Conversion of existing residential into 1x1 bedroom maisonette and 1 x 3 bedroom maisonette (Class C3) 2011/6294/INVALID

56 Huntley Street,
London,
WC1E 6DD

For University College London Hospitals Charity (UCLHC)

Supporting Information

Typical Door @ scale 1.10

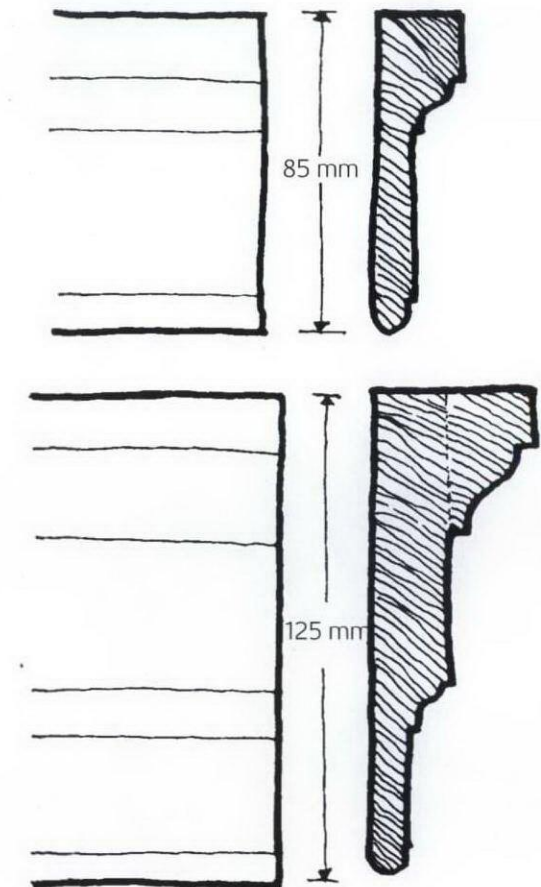
- 1.3.1 Agricultural Certificate not signed. This has been sent as a separate pdf file.
- 1.3.2 Elevation Drawing - Insufficient Detail
Please provide proposed drawings for each new type of door for each floor at scale 1:10 and architraves at 1:2.
See Page 4 for details

All internal doors to be half hour scfr with concealed closers, cold smoke seals and intumescent strips.
Butts to be mild steel, primed and painted to match existing retained doors.
Door furniture to be surface rimlocks with pressed metal body painted to match existing door ironmongery, polished brass knobs.
Door leaf to match existing opening.
Door thickness to manufacturer's advice subject to panelled construction achieving the required fire ratings.

Amended Ground Floor Plan
New Partition to staircase
Scale 1:20

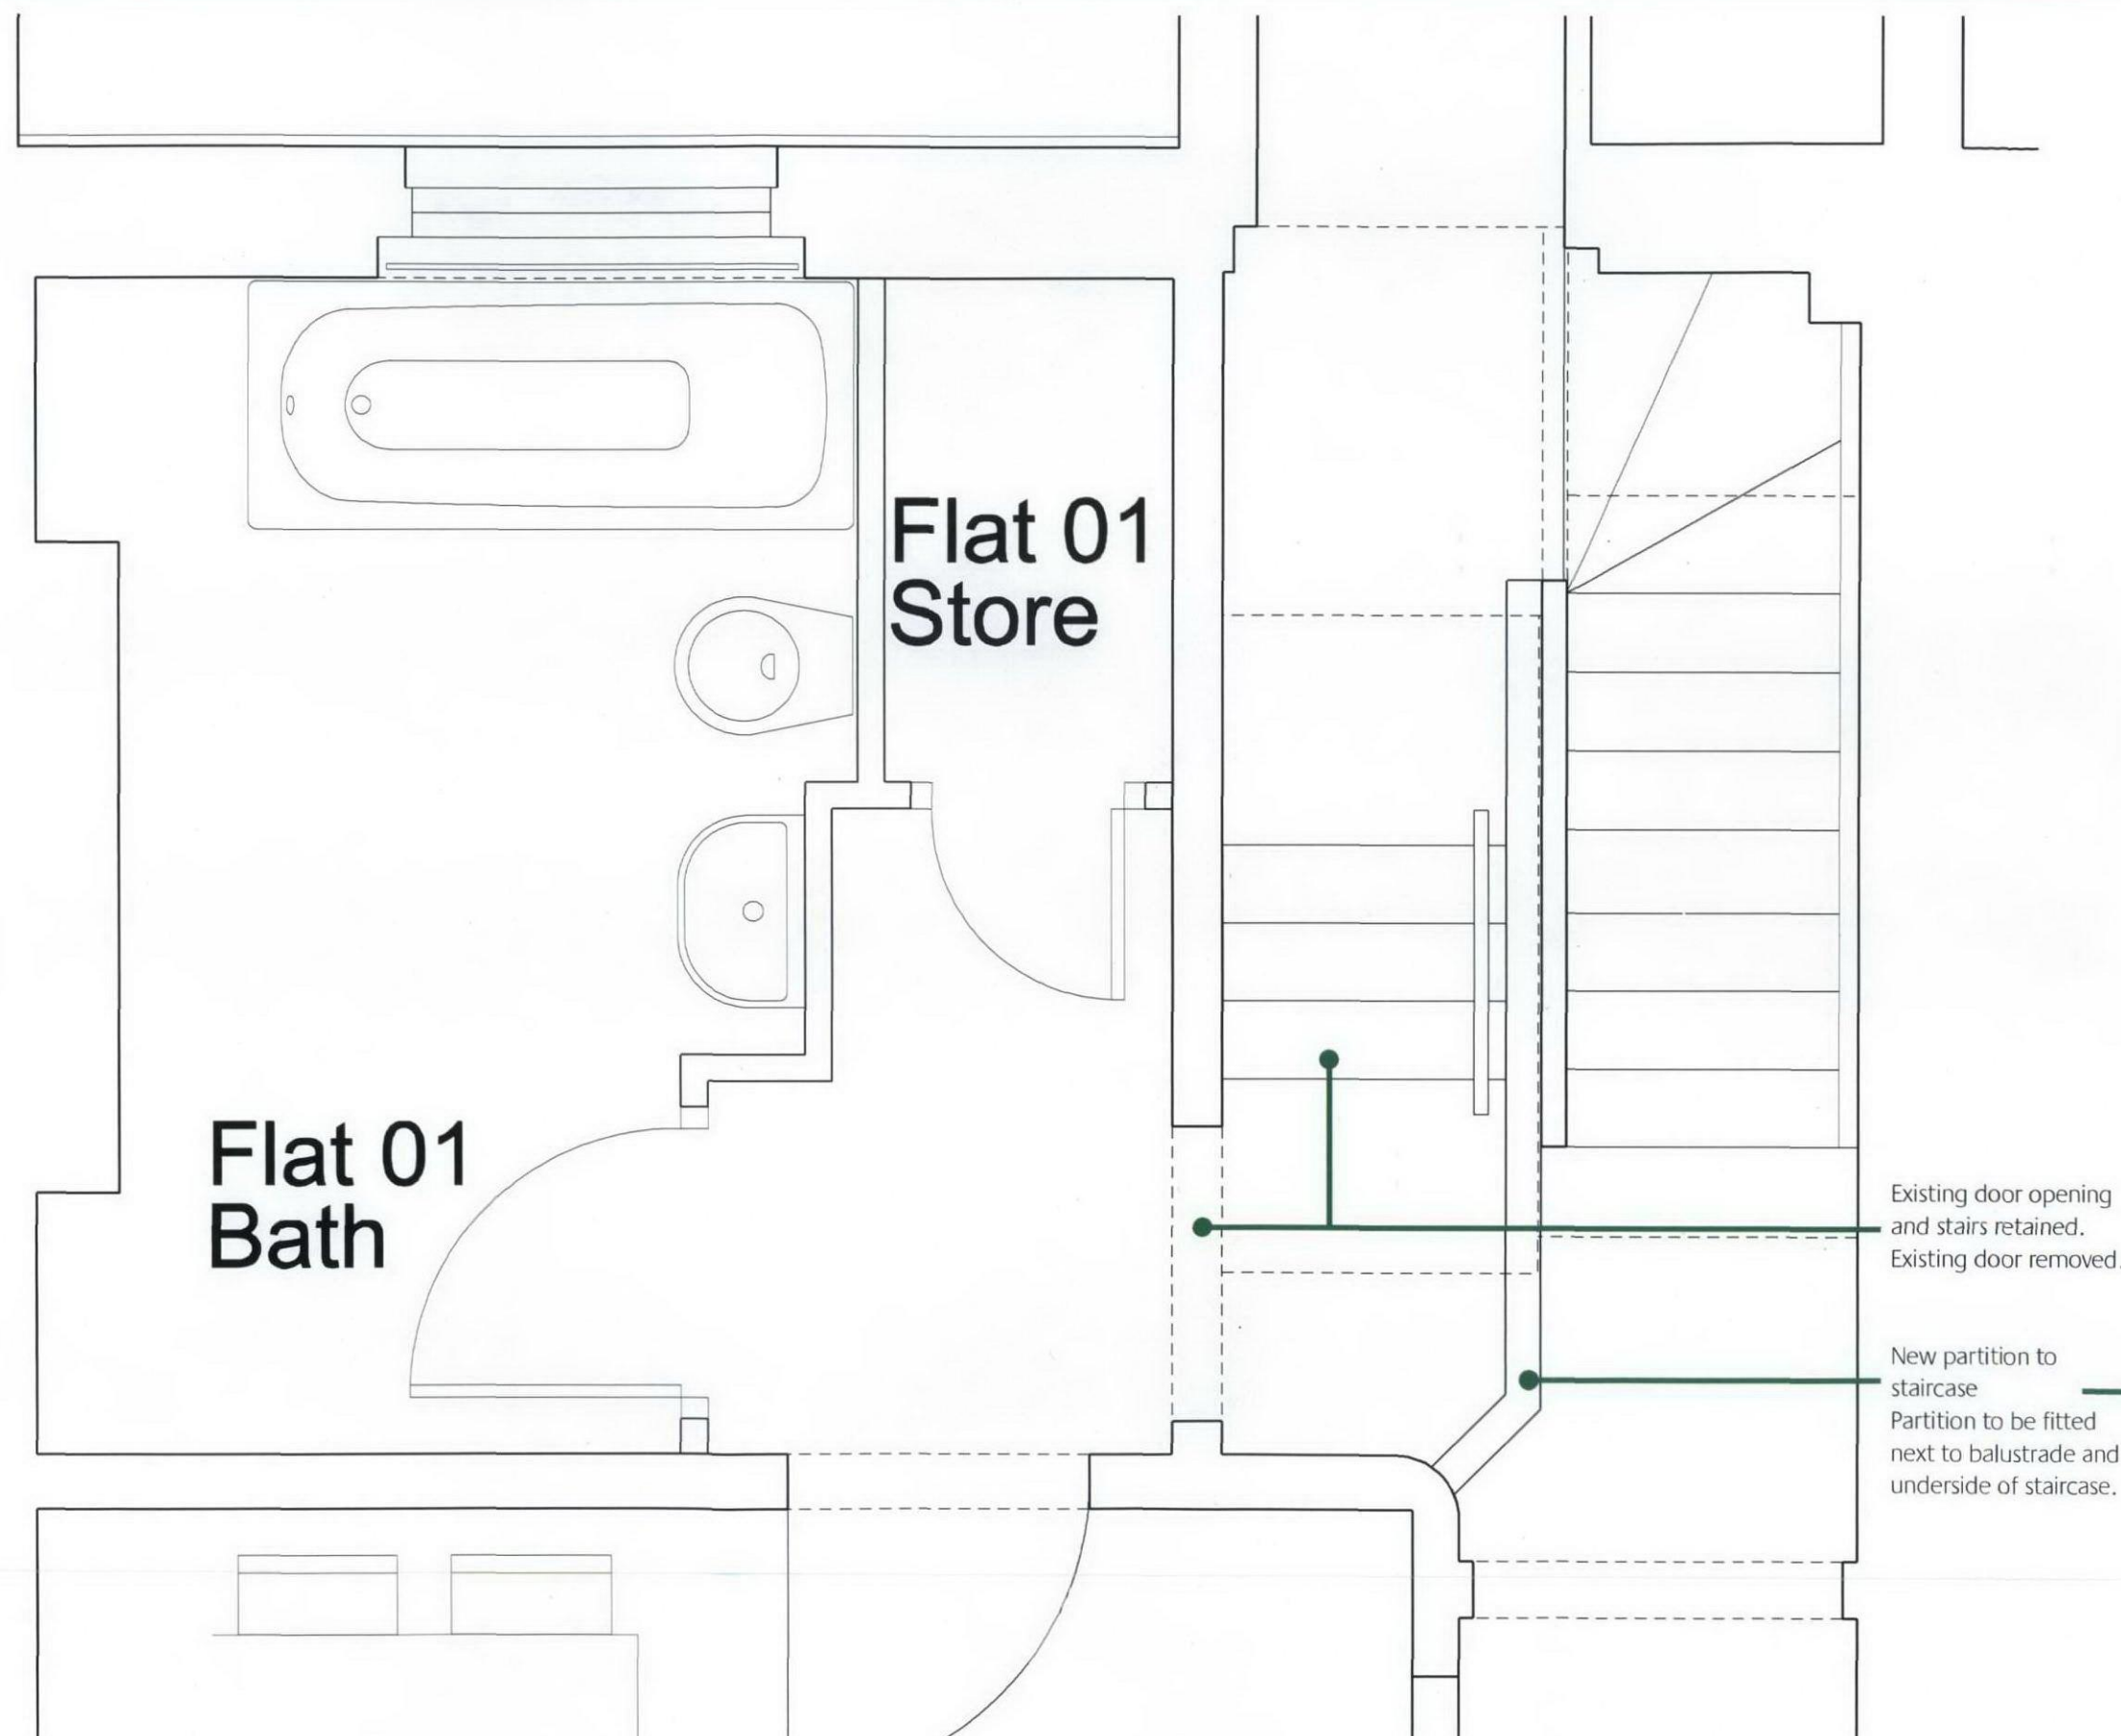
1.3.3 Elevation Drawings are required.
Please provide internal elevation drawings
of the ground floor level at a scale of 1:20
to show the new plasterboard partition and
its junction with the existing staircase.
See Page 5-9 for details.

Revised plan showing partition to staircase
as requested.

Existing door opening and door reveal
retained.

Floors, walls and ceilings to be constructed
from softwood framing and plywood
sheathing faced in plasterboard for internal
and external decoration.

Softwood packing and painted cover strips
to all junctions with walls and ceilings to
be tailored to individual site conditions to
ensure accuracy and avoidance of damage
to existing building fabric and decorations.

1.3.3 Elevation drawings of staircase @ 1:20

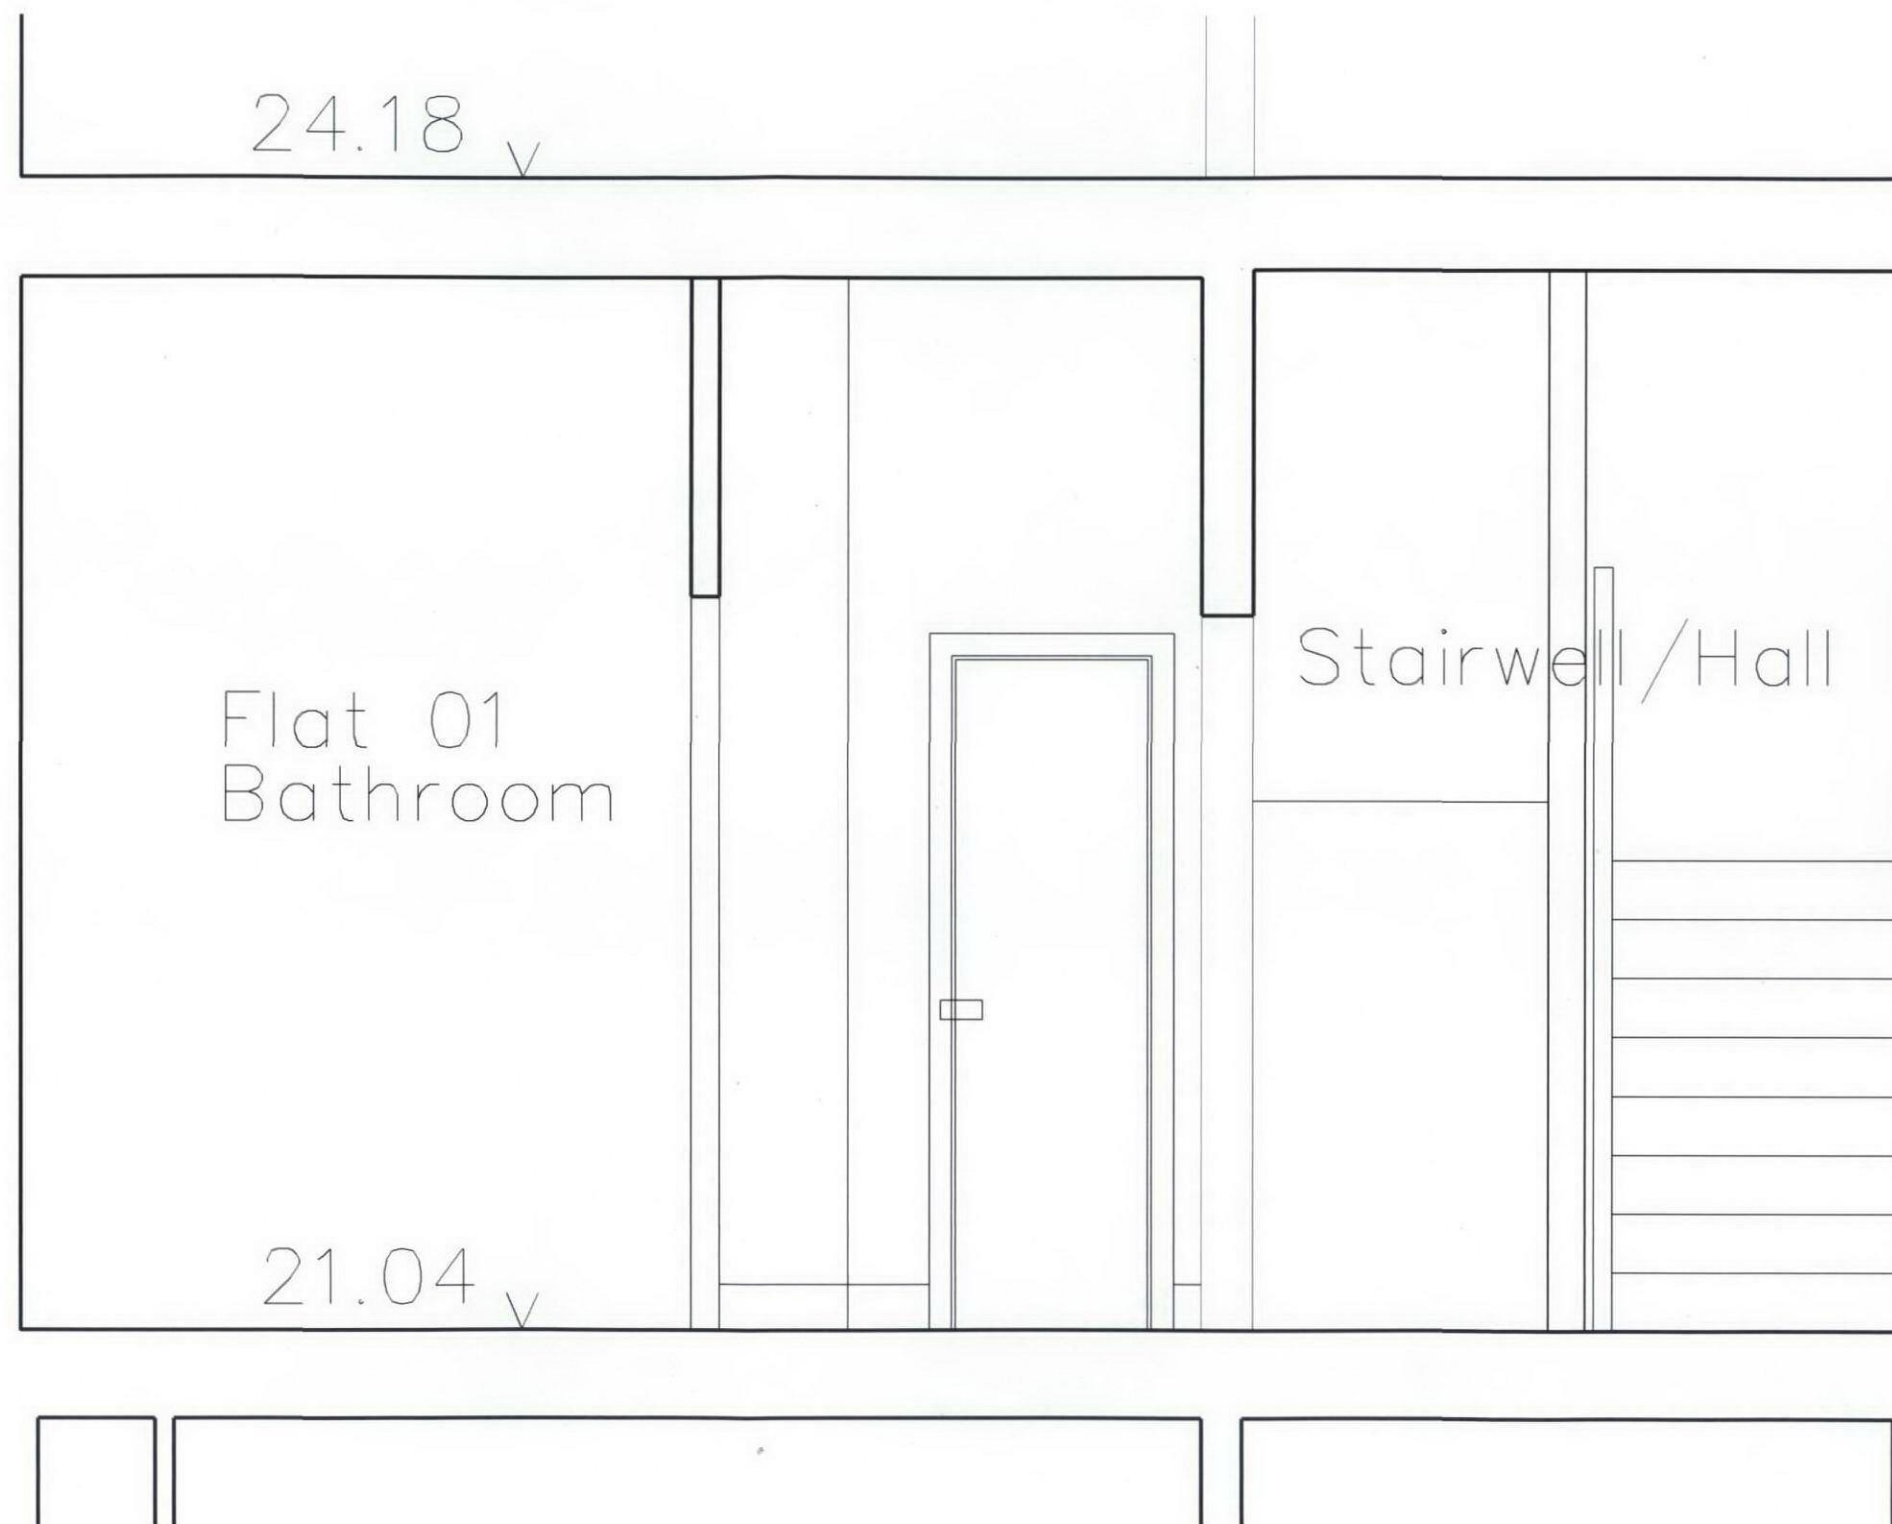
- 1.3.3 Elevation Drawings are required.
Please provide internal elevation drawings of the ground floor level at a scale of 1:20 to show the new plasterboard partition and its junction with the existing staircase.
See Page 5-9 for details.

First floor Plan
Scale 1:50

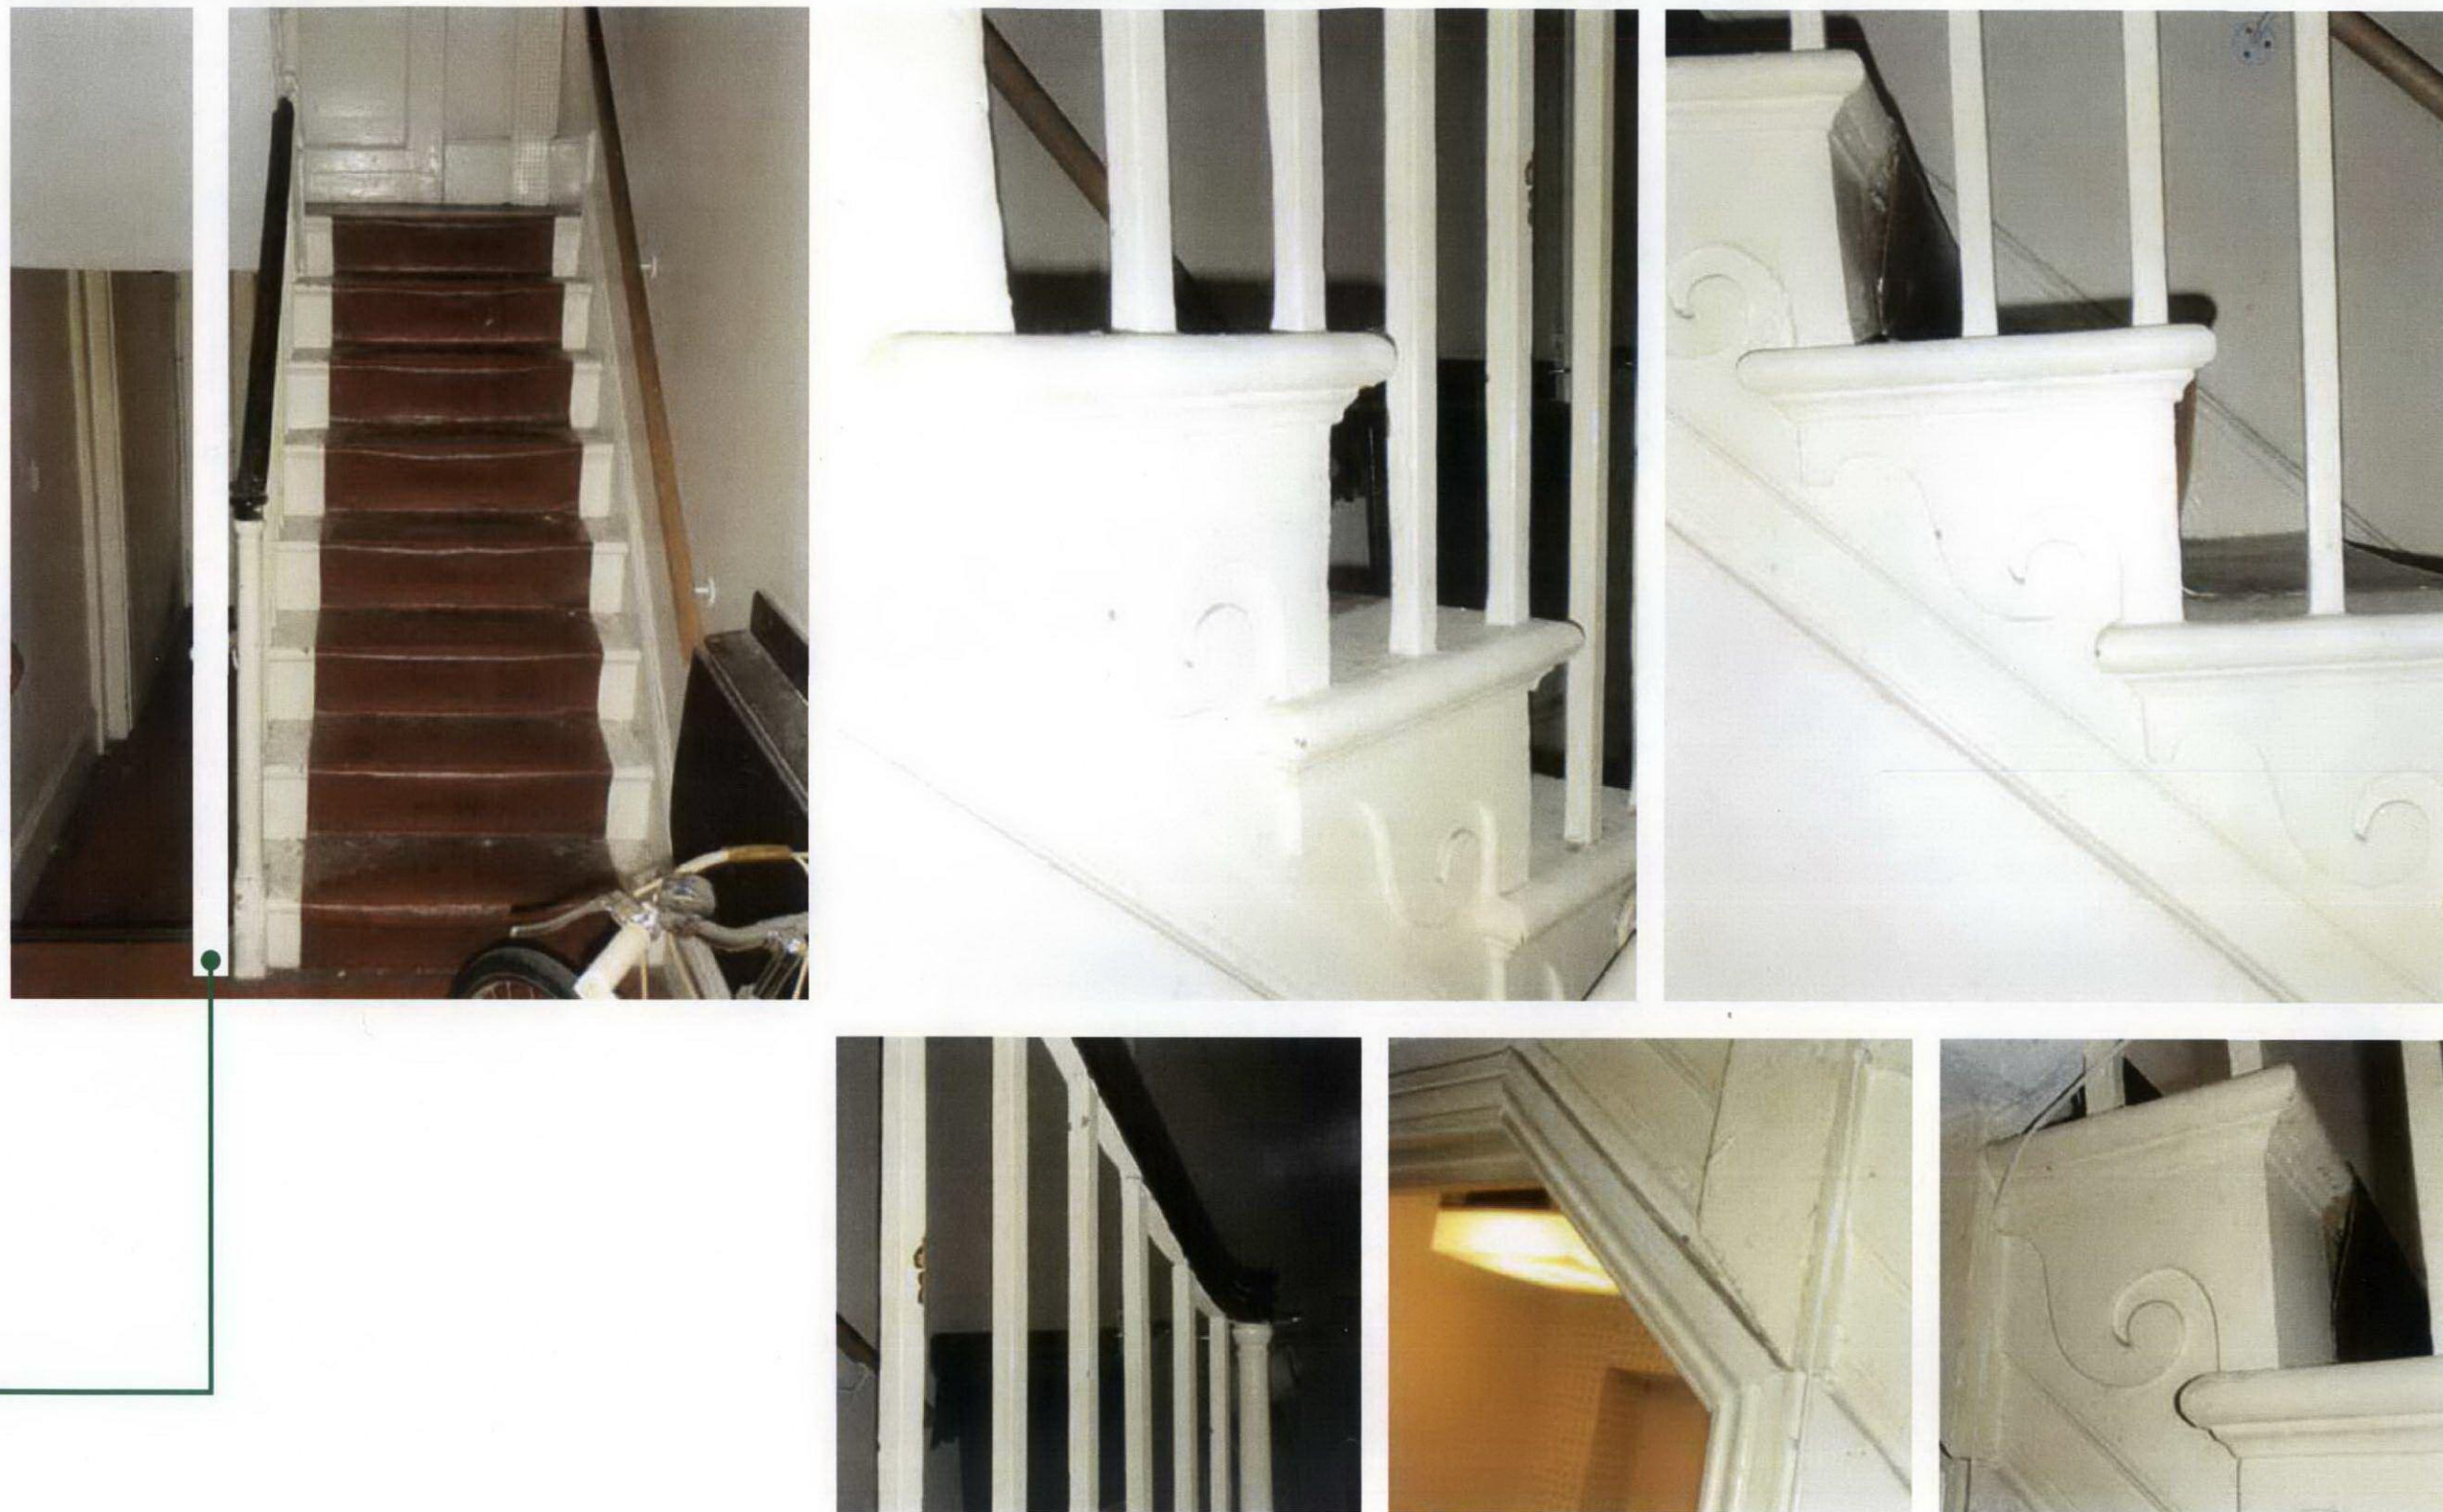
1.3.4 Floor Plans - Insufficient Detail

First floor plan annotated to show joist runs and pipe work associated with the new kitchen and elevation drawing to show any proposed cooker flue (not shown on any drawings).

First floor plan provided with joist runs and pipework location
